**AGENDA
PLANNING COMMISSION
CITY OF WYOMING, MINNESOTA
OCTOBER 26, 2021
7:00 PM**

TO: Planning Commission
FROM: Tom Ramler-Olson, City Planner
Fred Weck
MEETING DATE: October 26, 2021
RE: Preliminary & Final Plat Review of Aadland Acres 3rd Plat
APPLICANT / Perry Aadland, Peter Aadland, Paul Aadland
OWNER: Perry Aadland, Peter Aadland, Paul Aadland
PROPERTY: PID R21.10482.00
FILE NO.: D-21-011 & D-21-012

TO: Planning Commission
FROM: Tom Ramler-Olson, City Planner
Fred Weck
MEETING DATE: November 9, 2021
RE: Site Plan review of Hallberg Multi-Tenant Site Plan
APPLICANT: Advanced Engineering Concepts (Matt Appel)
PROSPECTIVE OWNER: Hallberg Inc. (Austin Hallberg)
CURRENT OWNER(S): Chisago County EDA and City of Wyoming EDA
PROPERTY: PID 21.00006.00
FILE NO.: SP-21-004

No.	Description	Date
Issue Date	DESIGNED BY: KMS DRAWN BY: KMS CHECKED BY: KMS	
Elevations		
A-201 1/8" = 1'-0"

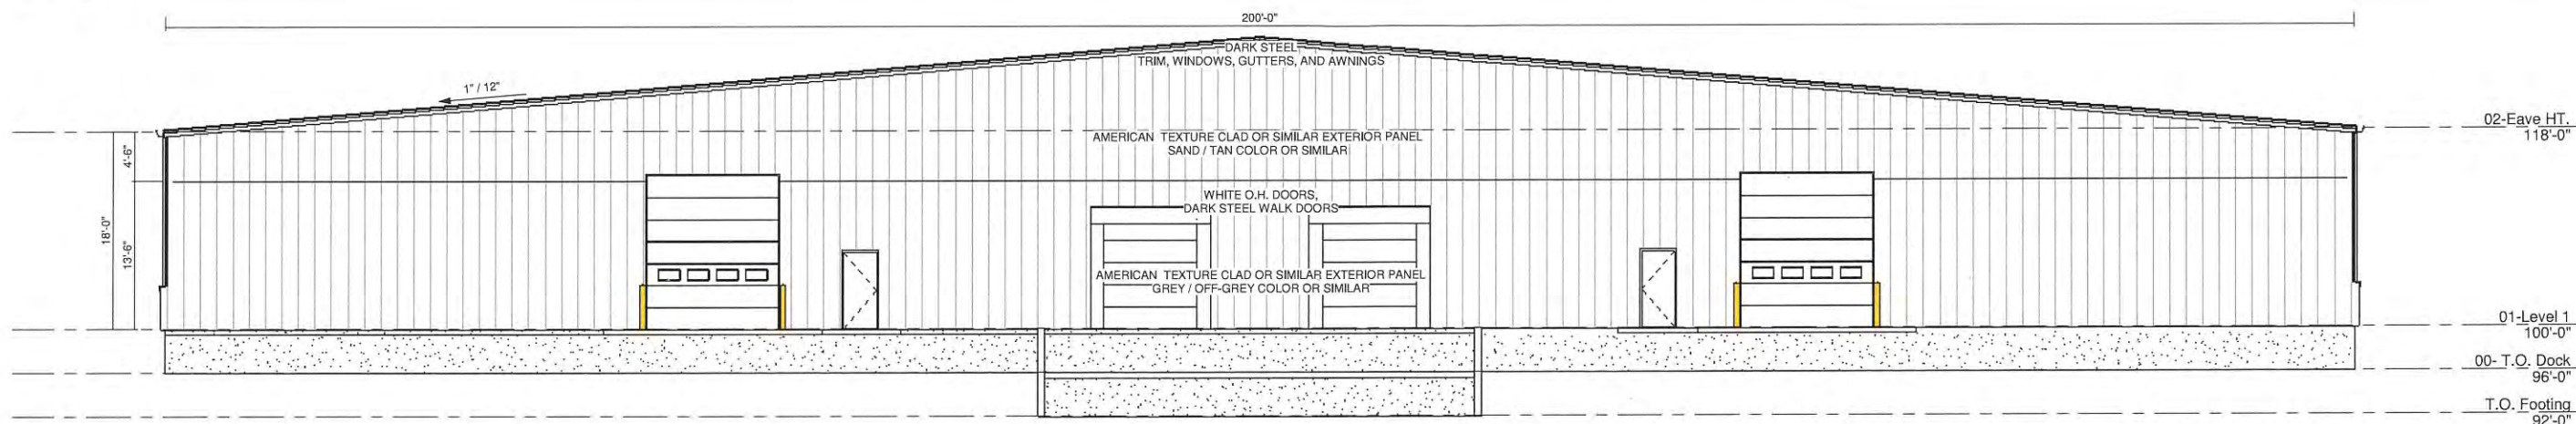
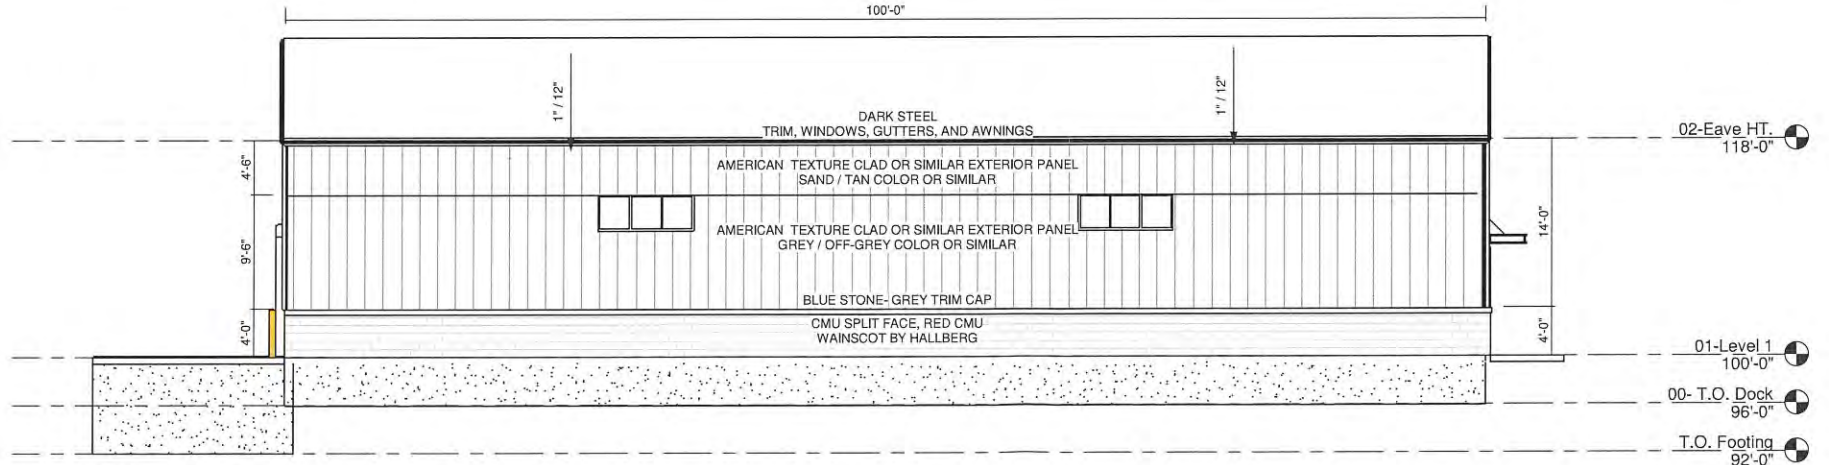
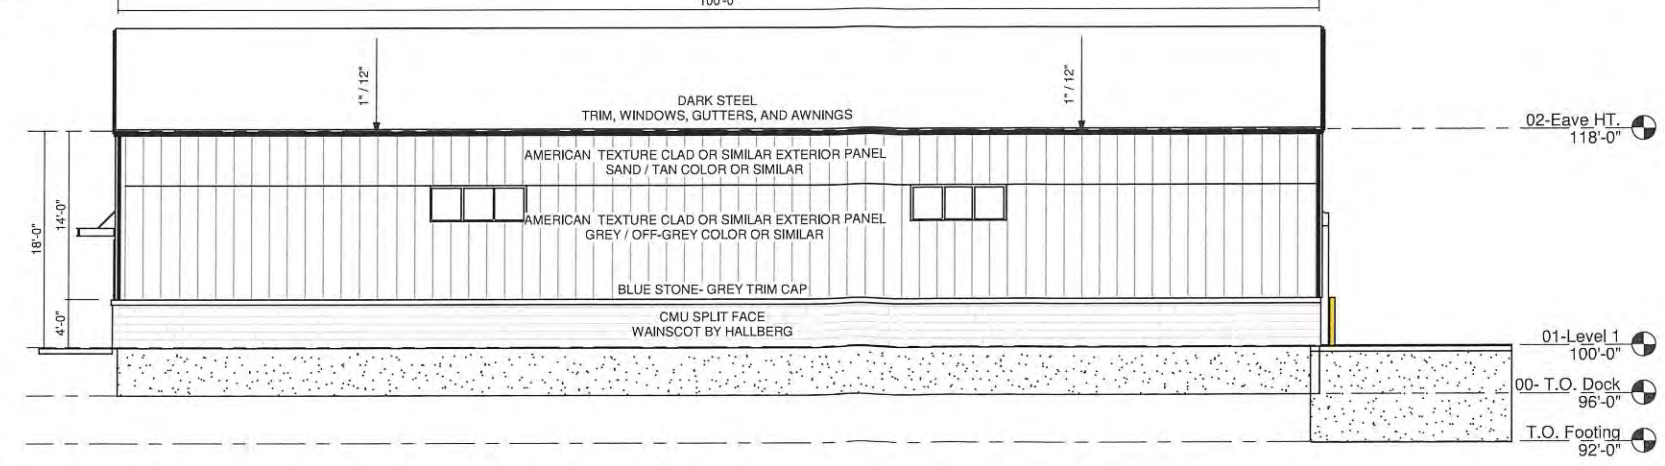
1. Texture-Clad panels are stainless steel wall panels designed with a stucco finish. Masonry stucco is considered a Class II material, which is limited to 35% of the exterior under the Code. The applicant shall revise the building design so that it incorporates more exterior material(s) from Class I that are compatible with the rules in Section 40 – 450 with percentages labeled indicating each class material. A building permit shall not be issued until such plans meet the rules in Section 40 – 450.
2. A cross-access agreement will be required to provide access to the phase 2 property.
3. All engineering comments (both detailed redline comments on the plans as well as comments in the staff report) will be required to be addressed prior to approval of plans.

Commercial structures must provide a cohesive architectural appearance reflecting its functional purpose and must be composed of at least sixty-five percent (65%) Class I materials; not more than thirty-five percent (35%) percent Class II or Class III materials as per Section 40 - 450. Texture-Clad panels are stainless steel wall panels designed with a stucco finish. Masonry stucco is considered a Class II material, which is limited to 35% of the exterior under the Code.
